RESPONSE TO REQUEST FOR ADDITIONAL INFORMATION

US-APWR Design Certification

Docket No. 52-021

RAI NO.: NO. 812-5983 REVISION 3
SRP SECTION: 03.07.02 – Seismic System Analysis
APPLICATION SECTION: 3.7.2
DATE OF RAI ISSUE: 08/23/2011

Figure 1 ATF at Center, Basemat Bottom (El. -39.667 ft), N-S Direction, 270-200 Soil

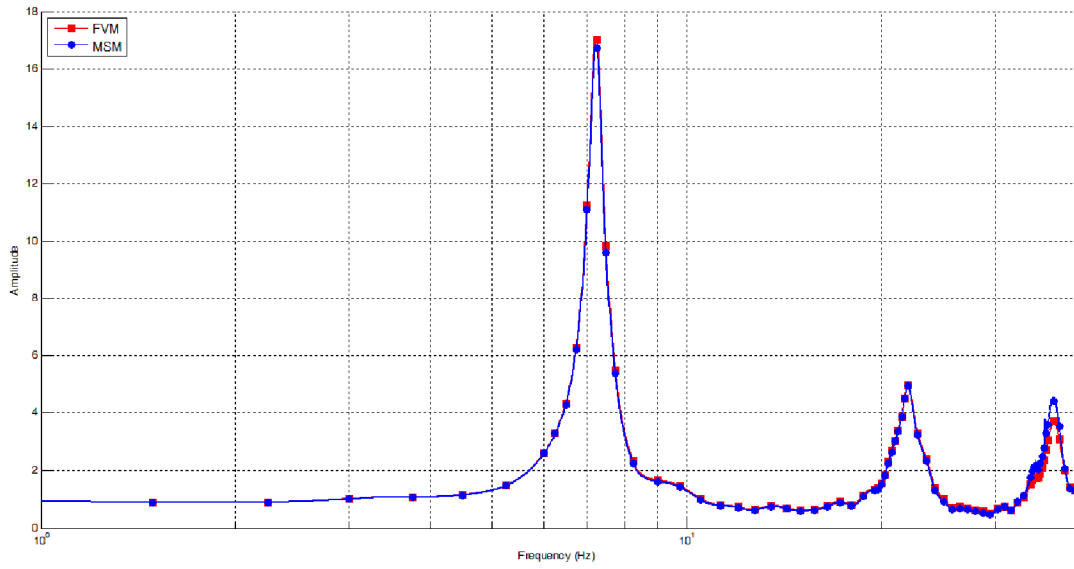
Figure 1 to Figure 4 present typical ATF and ARS comparison plots at a typical location, center of basemat bottom, from Study 1 for fully bonded embedment condition. Figure 5 to Figure 6 present the typical results of Study 2 at the reactor support. Review of the ATF and ARS comparison plots indicated that the acceptance criteria are met for both Study 1 and Study 2. The 5% damping ARS computed using MSM at reviewed locations match closely to the 5% damping ARS using FVM. At a few frequencies for some locations, downward deviation of MSM is observed from Study 1 results but well below 15%.
